# Environmental Minor Project Refinement Form

Project Name: West of Devers Upgrade Project Request Prepared By: Sylvia Granados

Date Approval Required: 10/9/2018 Variance Request No.: 21

FIGURE 1  
Page 5 of 6

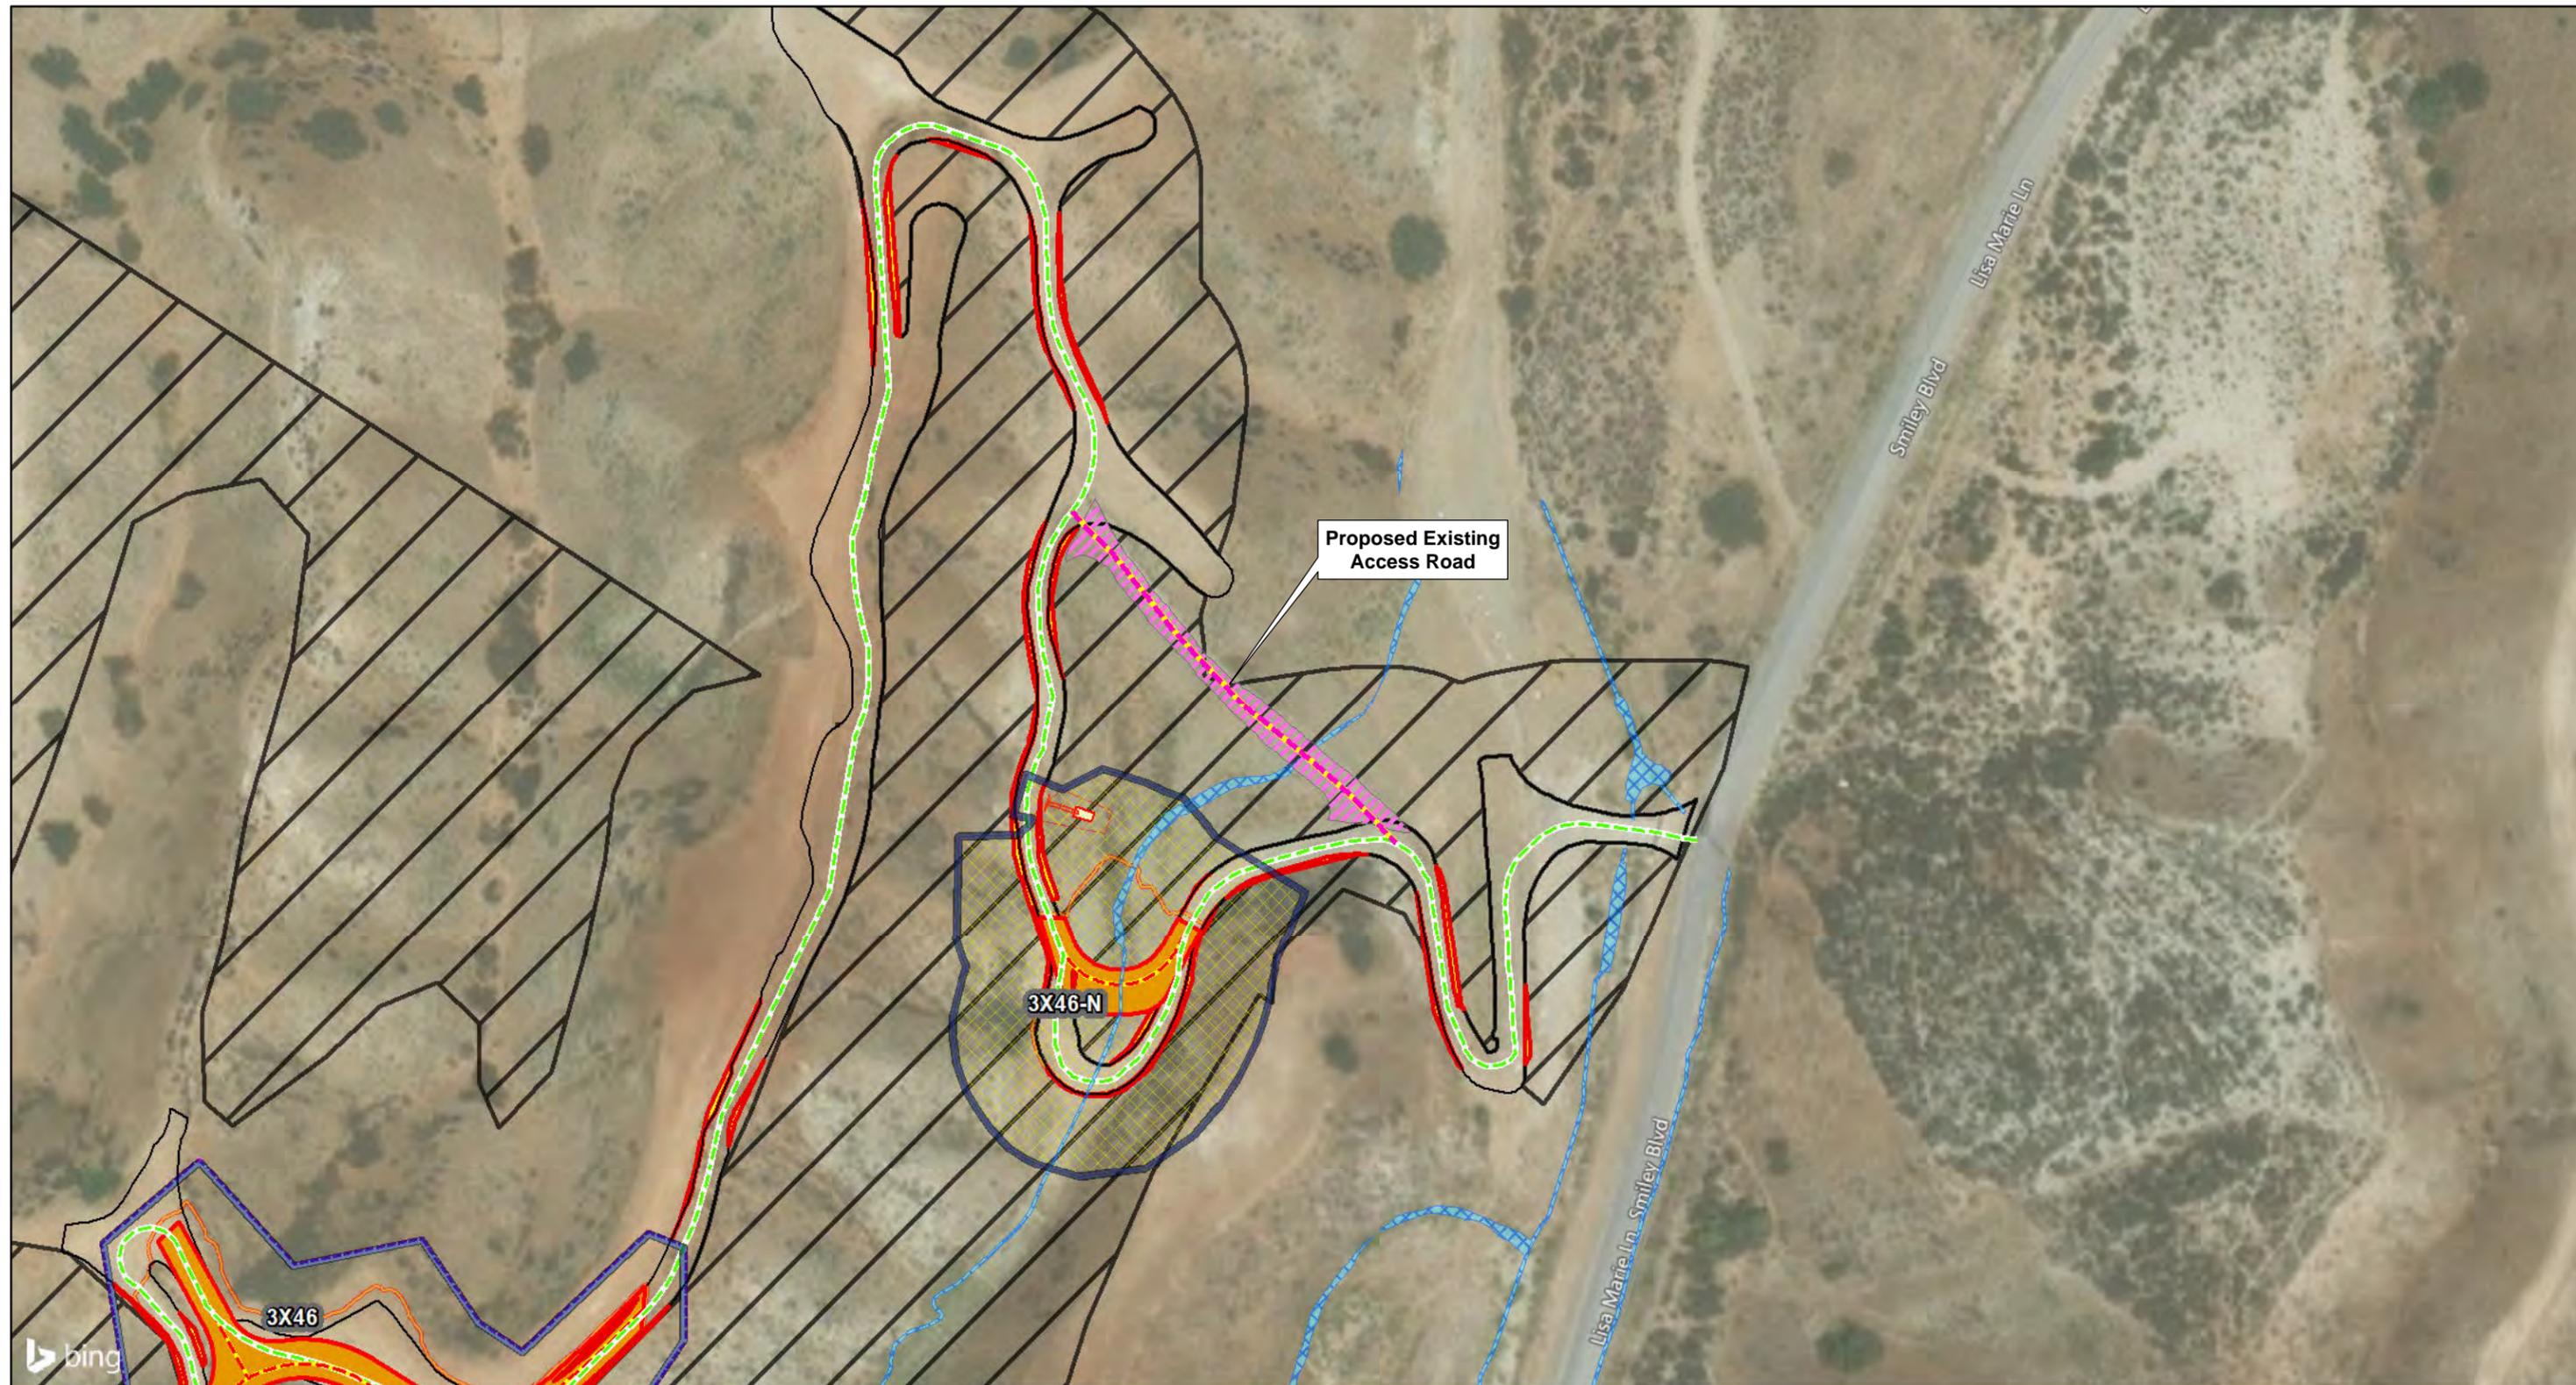
**Hydrant #6** – Potable hydrant supplied by the city of Colton, located near 1184 South Meadow Lane (34°2'56.19"N, 117°17'57.19"W) in the City of Colton, as shown on Figure 1, page 5.

FIGURE 2

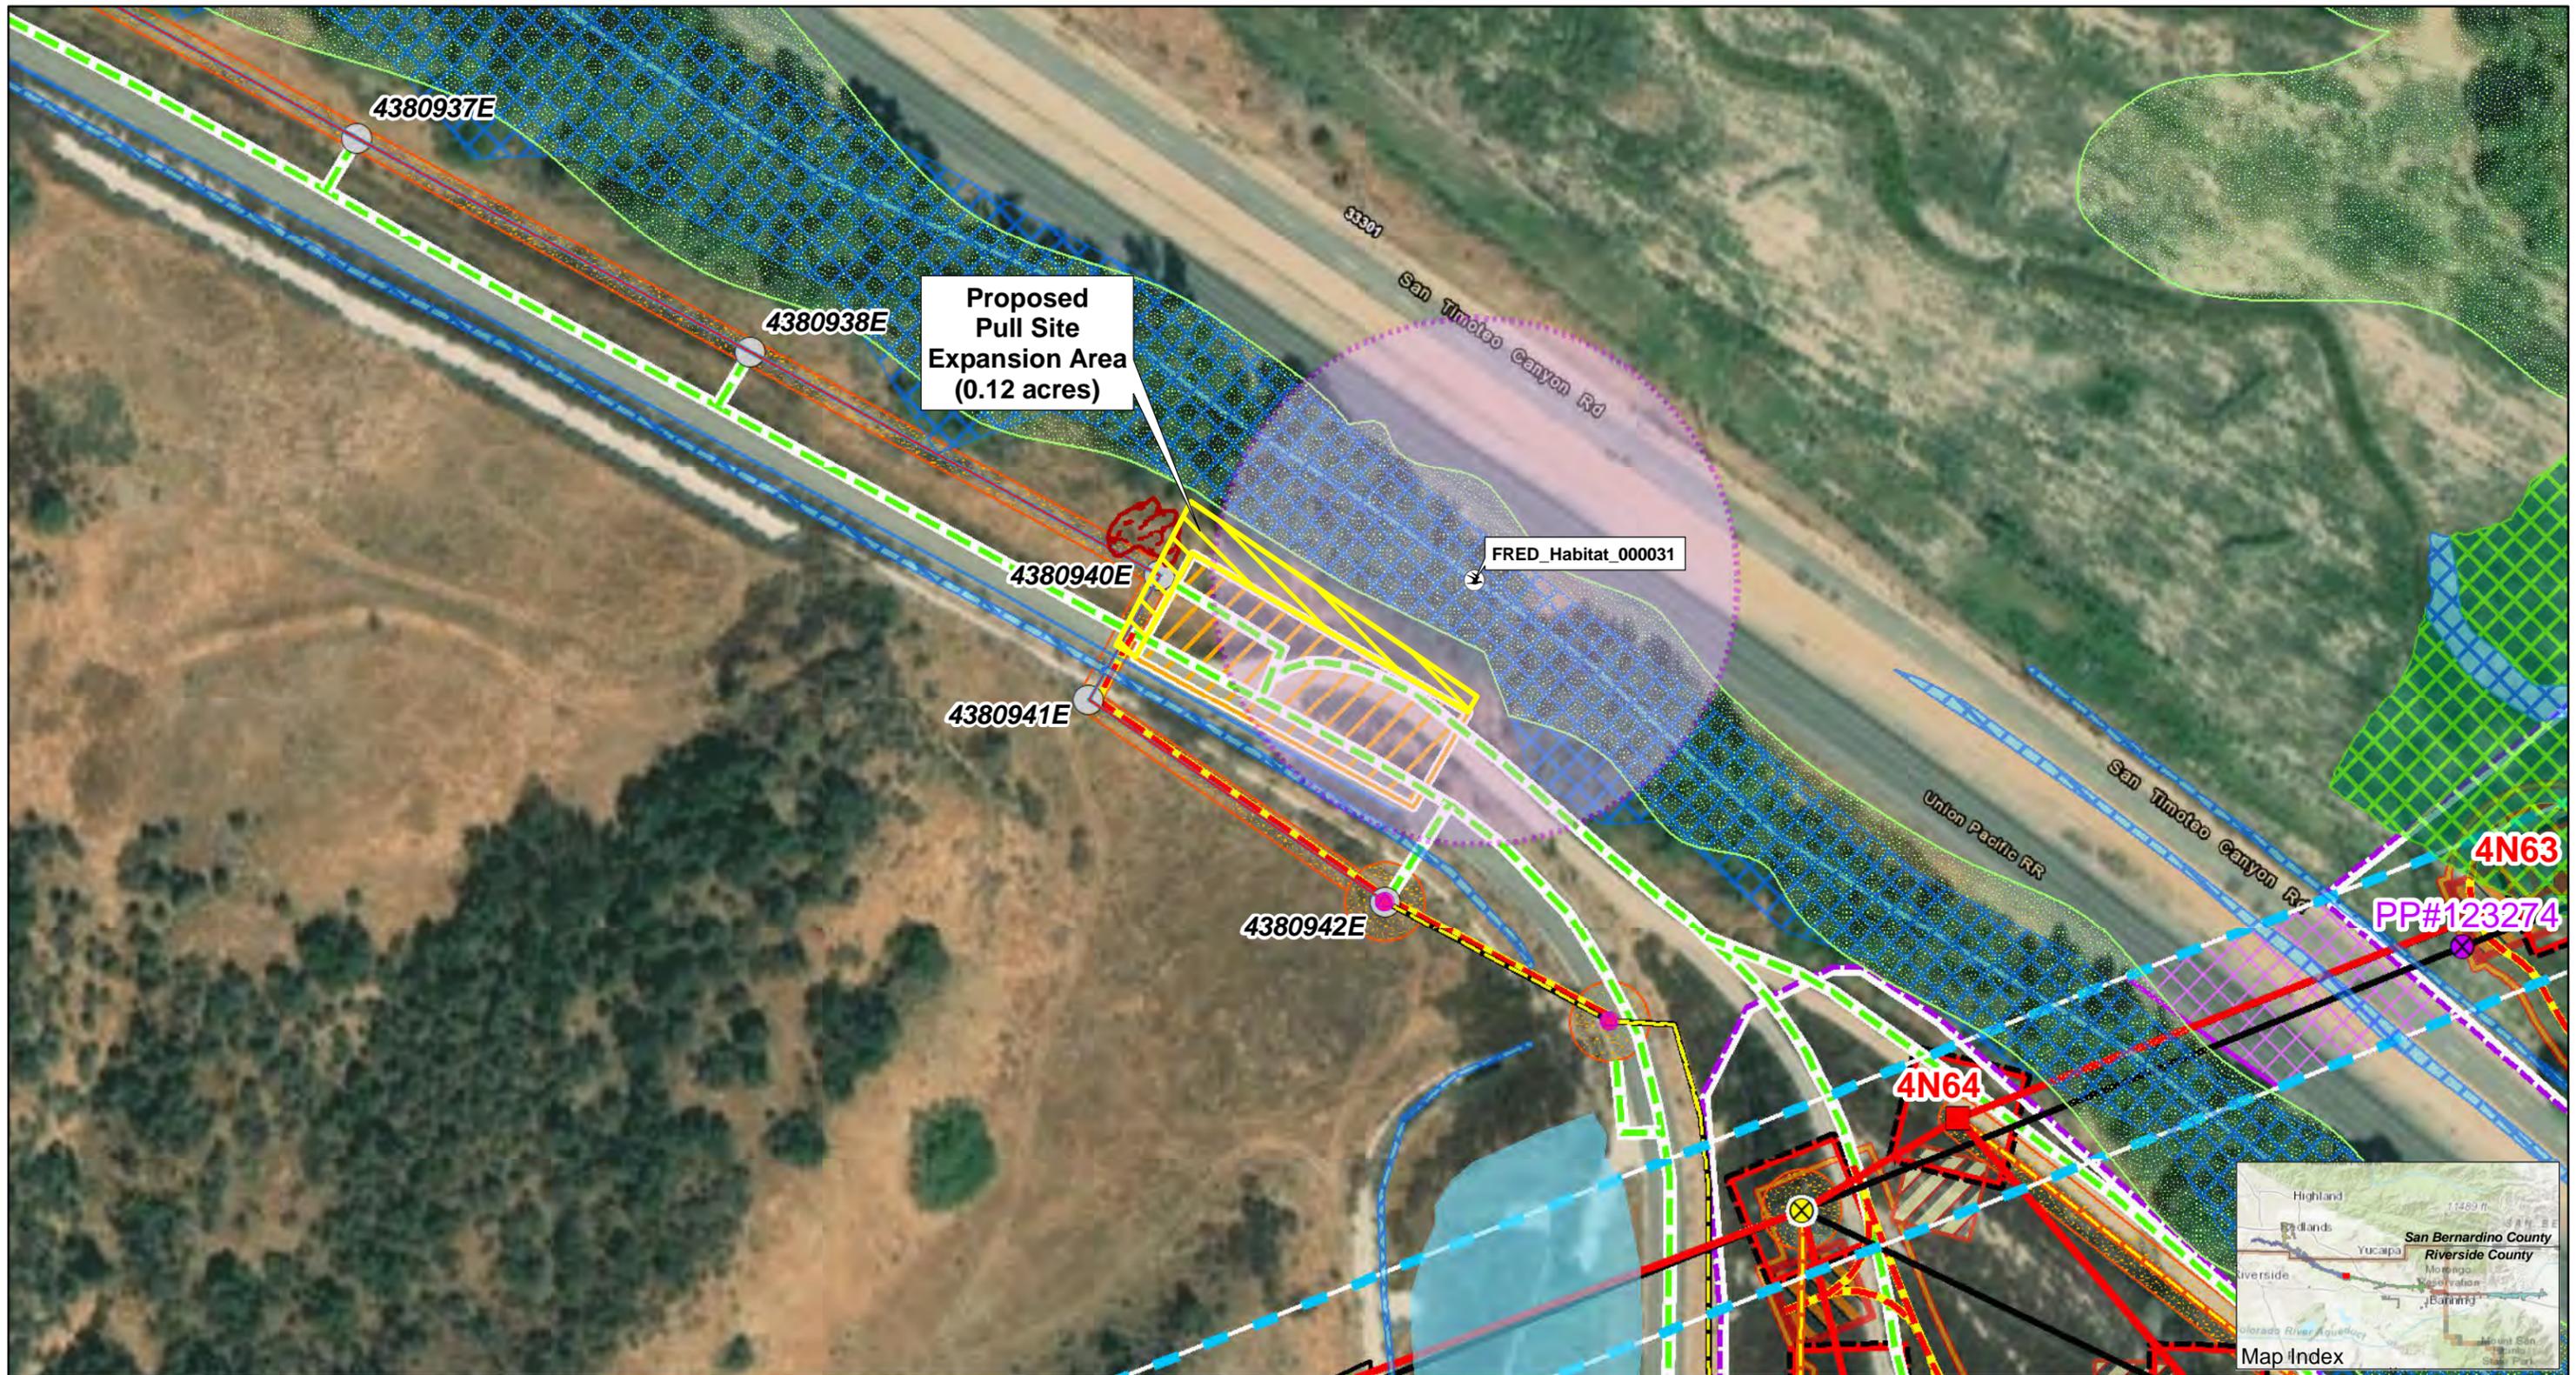
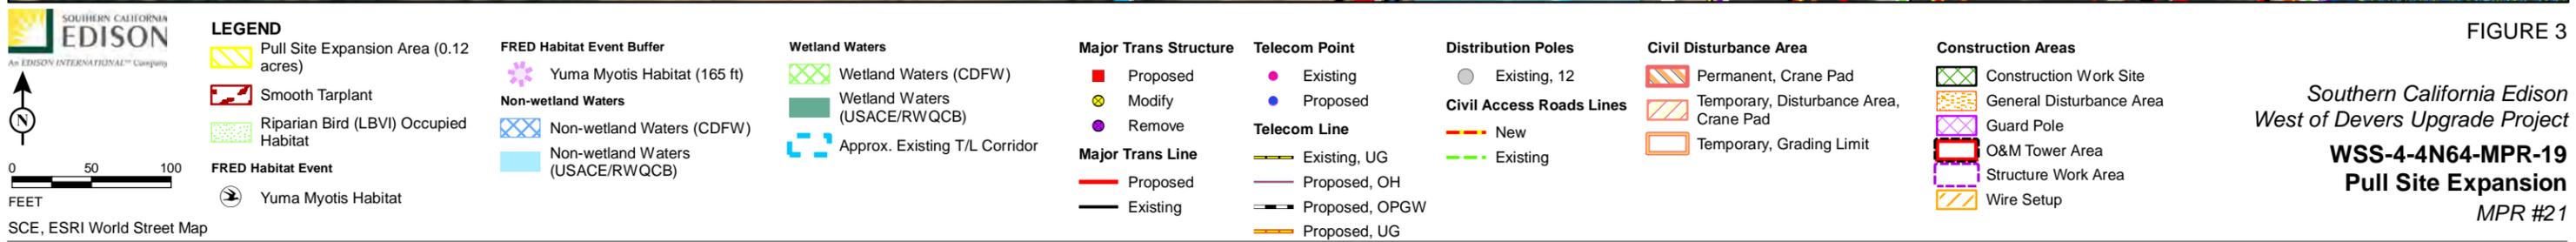
Use of an existing access road located on private property owned by Terrance L. Emershy, north of supersite 3X46-N, is required to minimize grading impacts at the proposed road widening site, as shown in Figure 2. The existing access road would provide more direct access to supersite 3X46 from Smiley Boulevard and minimize the need for grading improvements at supersite 3X46-N. The existing access road is approximately 290 feet in length by 20 feet in width and runs in a northwest to southeast orientation on previously disturbed land (34°0'30.08"N, 117°11'12.72"W), as shown in Figure 2.
